# FINAL DRAINAGE REPORT

**FALCON RANCHETTES FILING NO. 2**  
**MERIDIAN STORAGE**  
El Paso County, Colorado

VR239 and PPR2336

DATE:  
**April 24<sup>th</sup>, 2023**

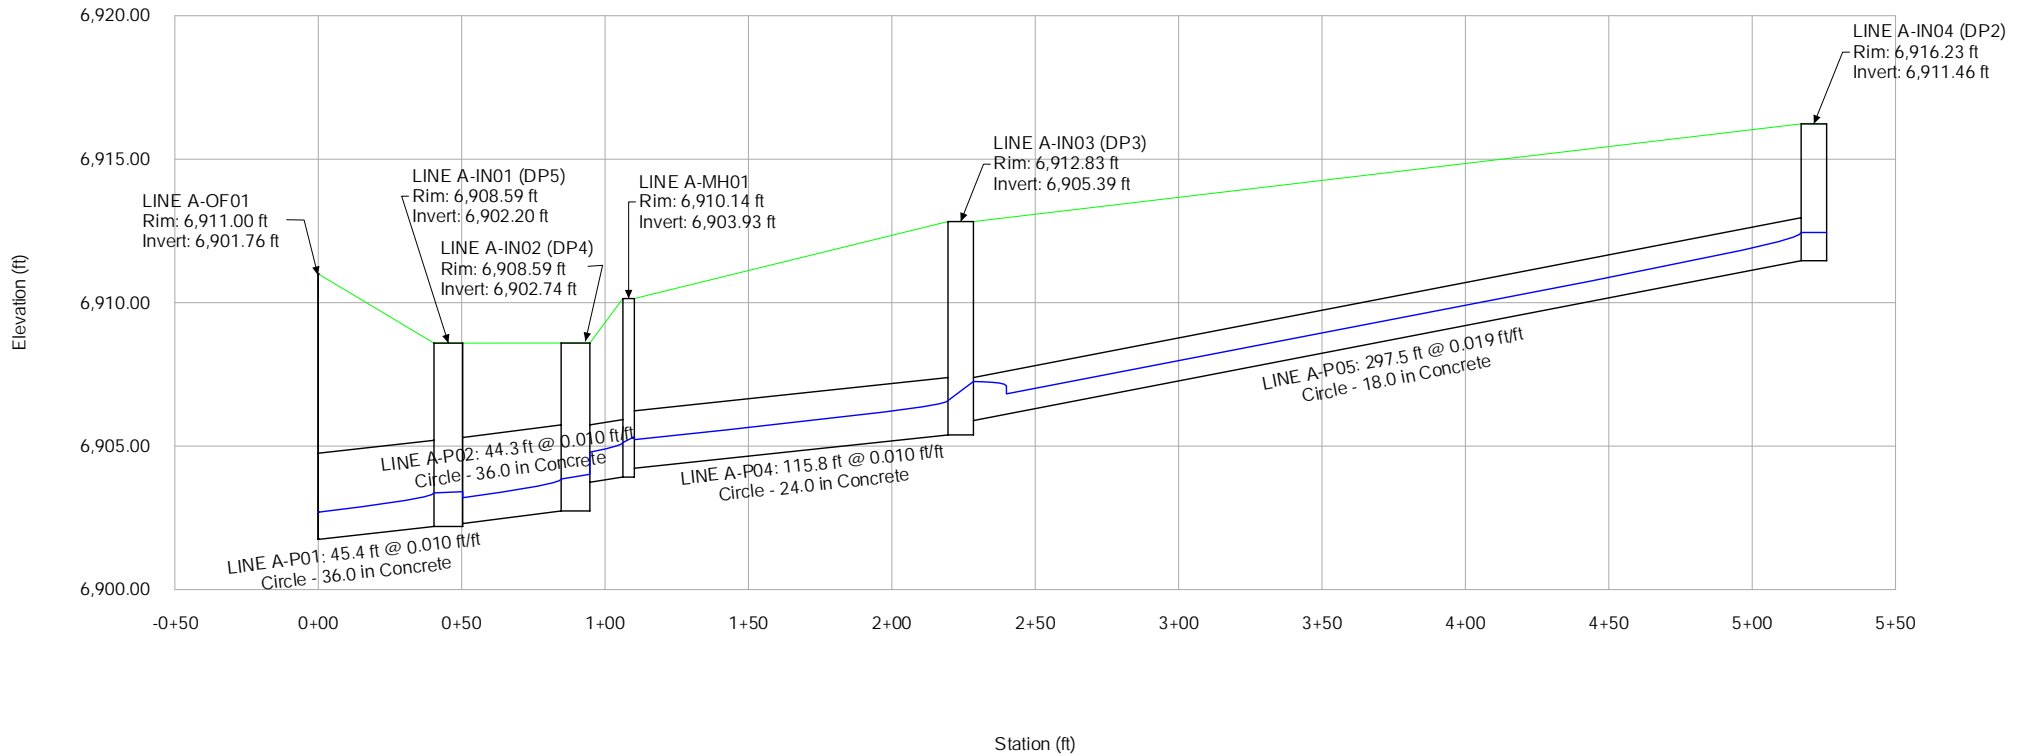
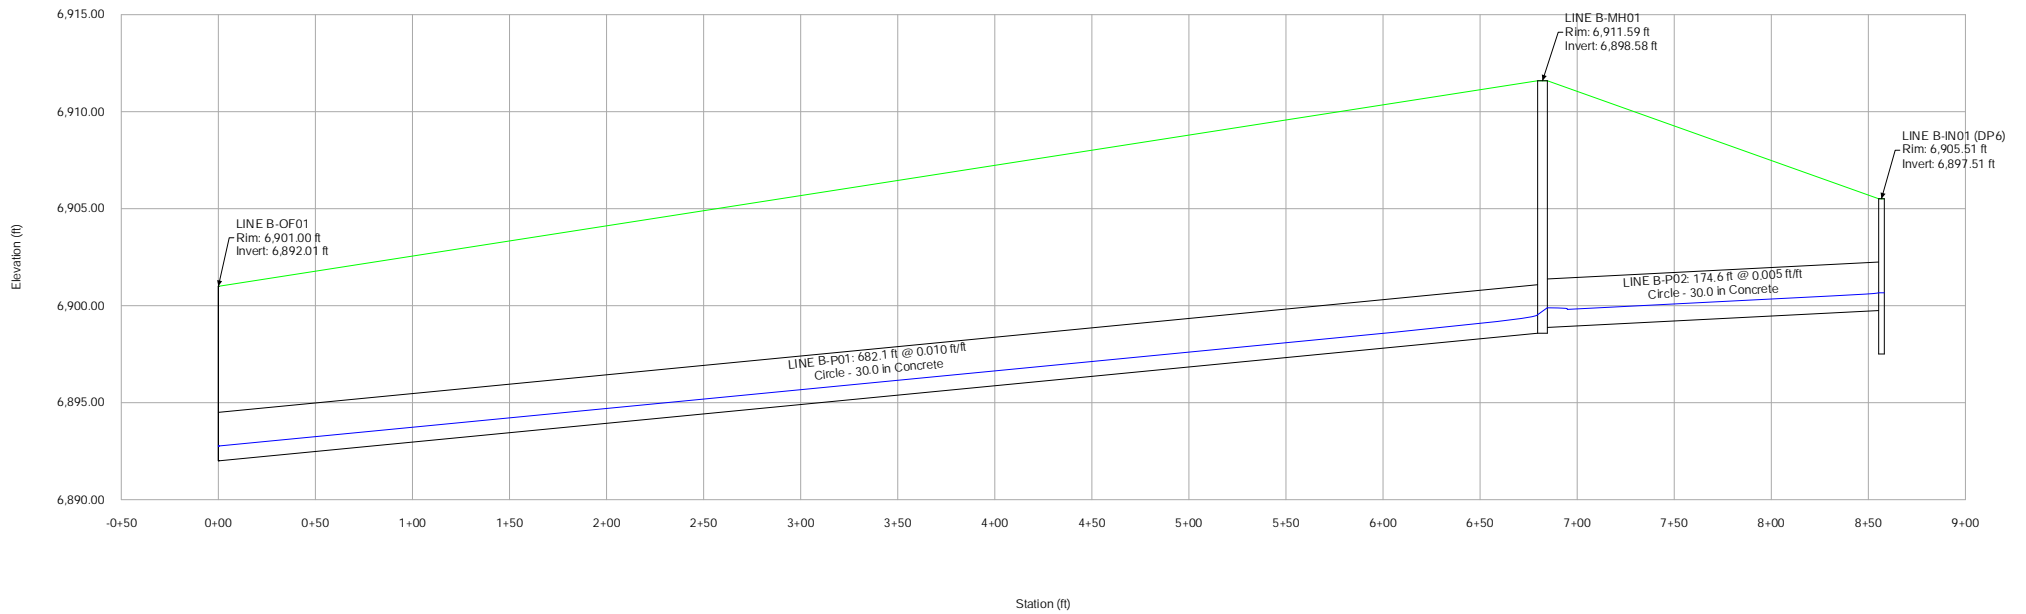
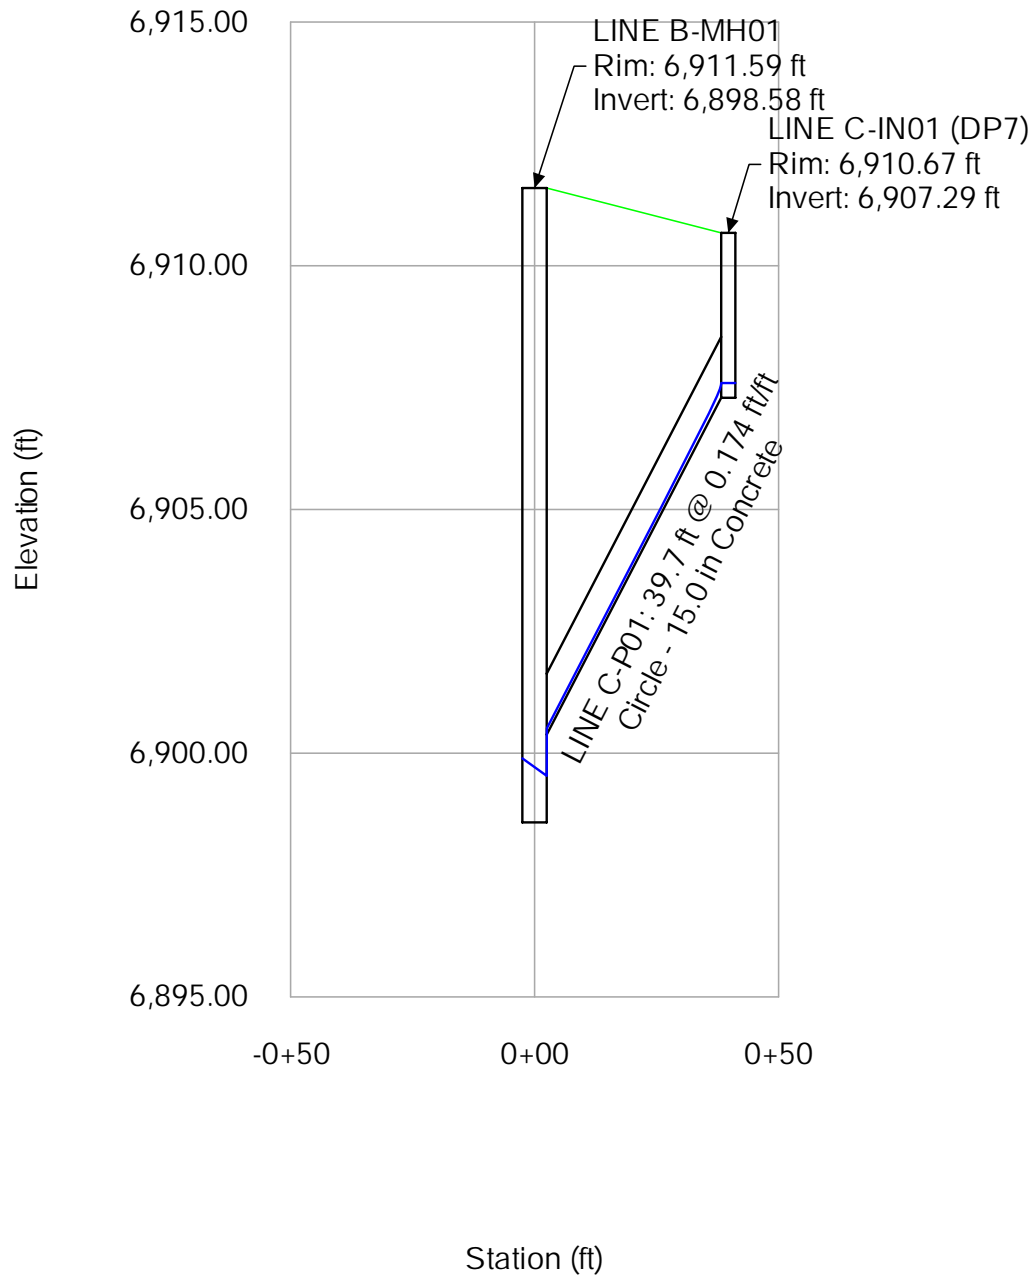
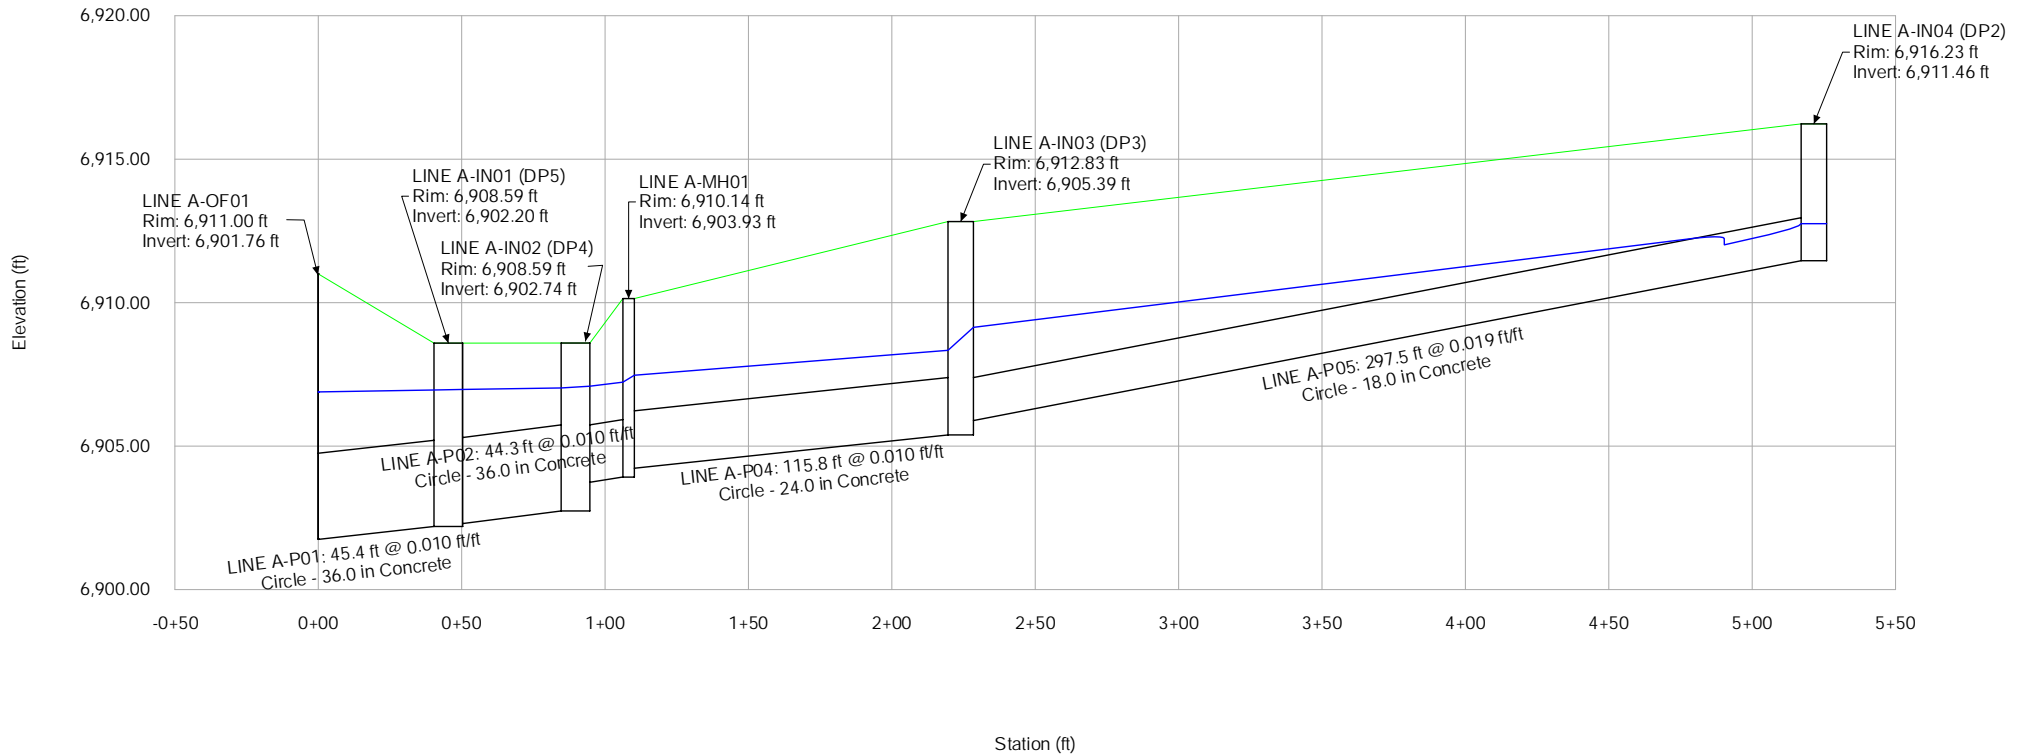
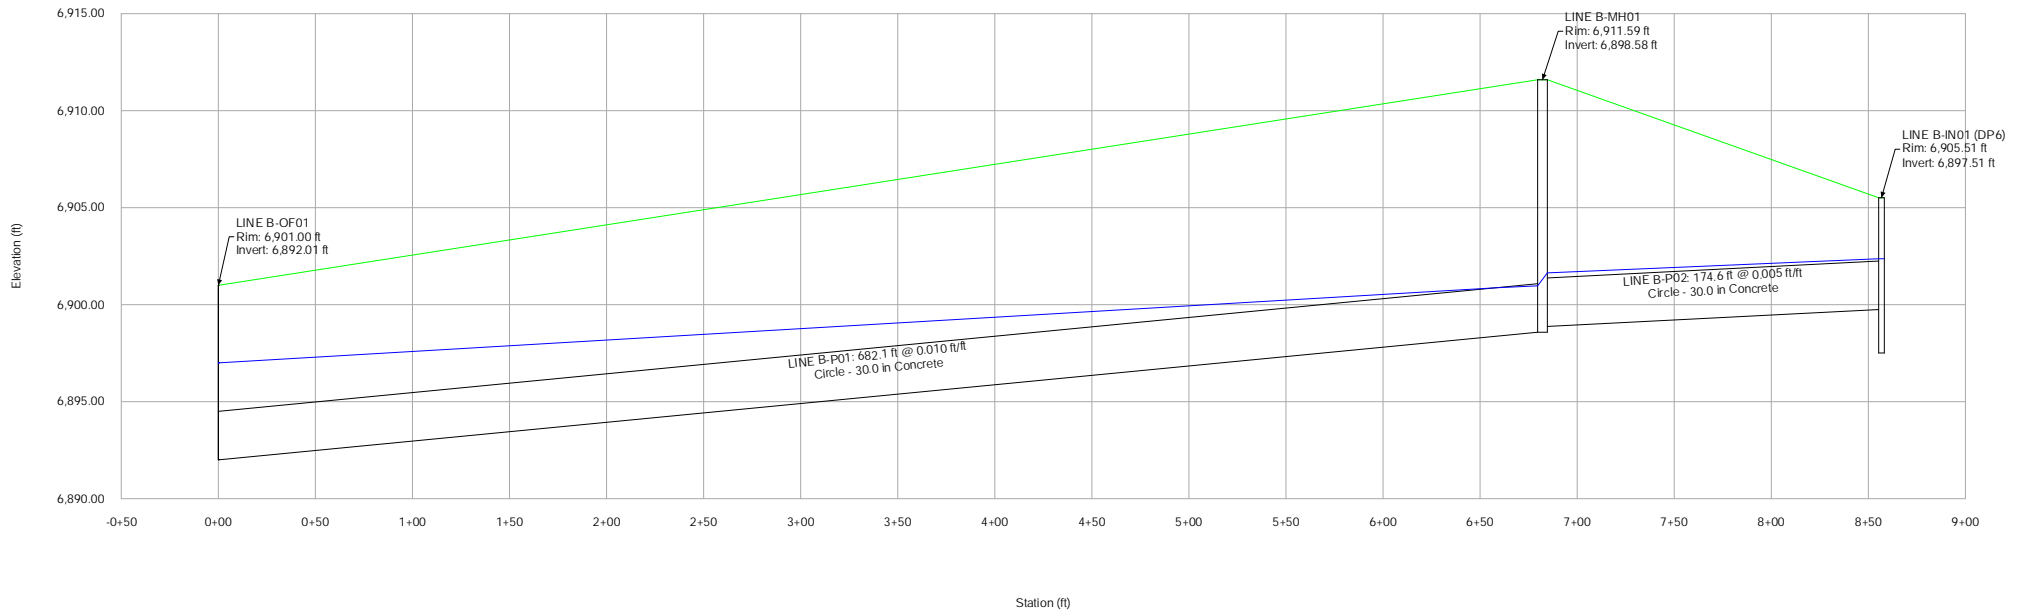
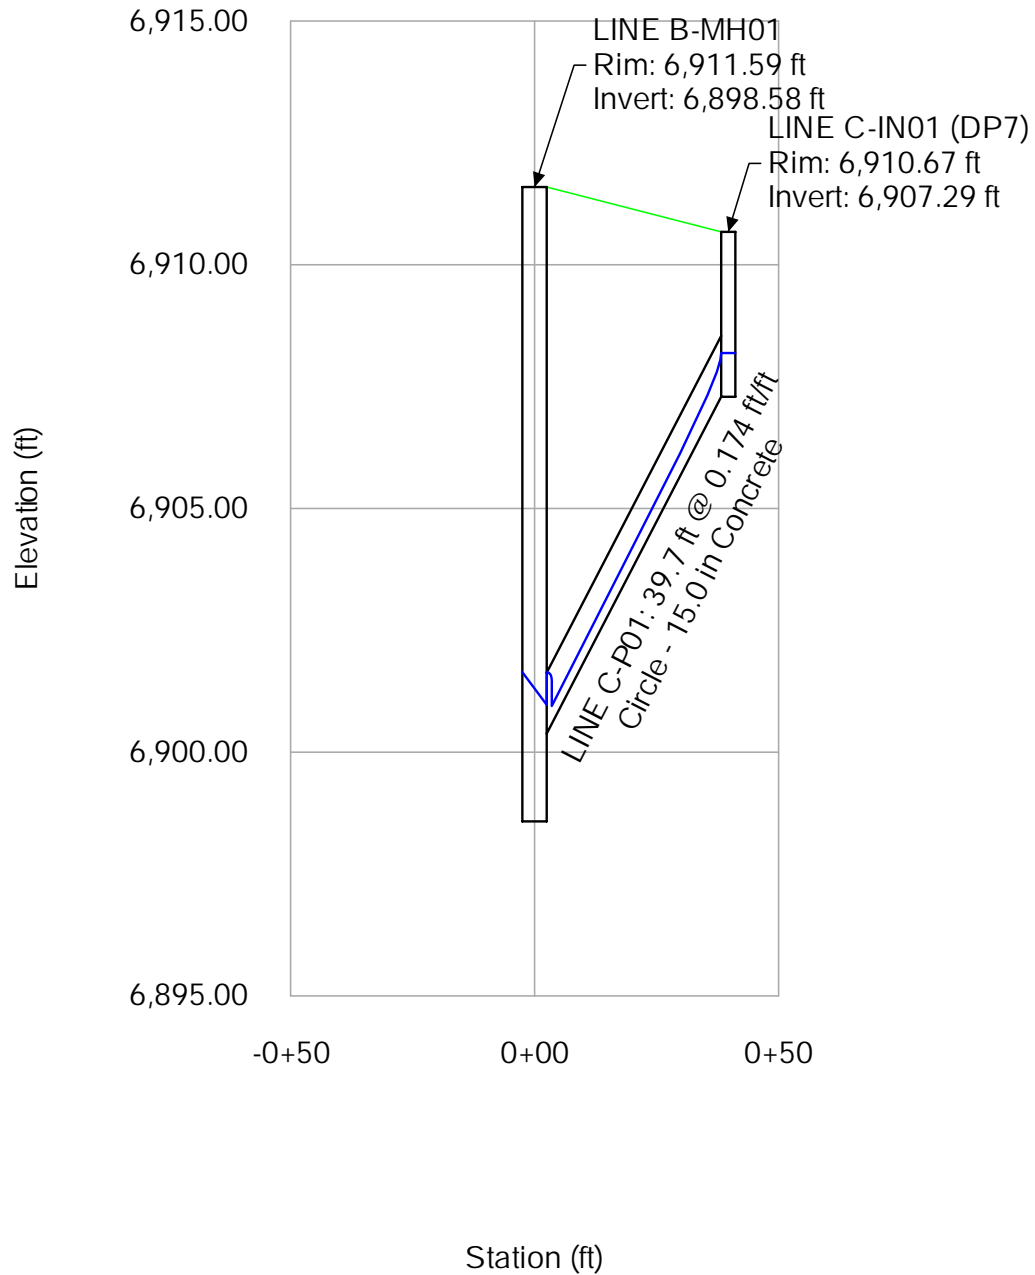
Account for the tailwater in the storm drain calculations. Line B-OF01 outfalls to the regional basin and line A-OF01 outfalls to Pond #1, both will likely with have some tailwater.
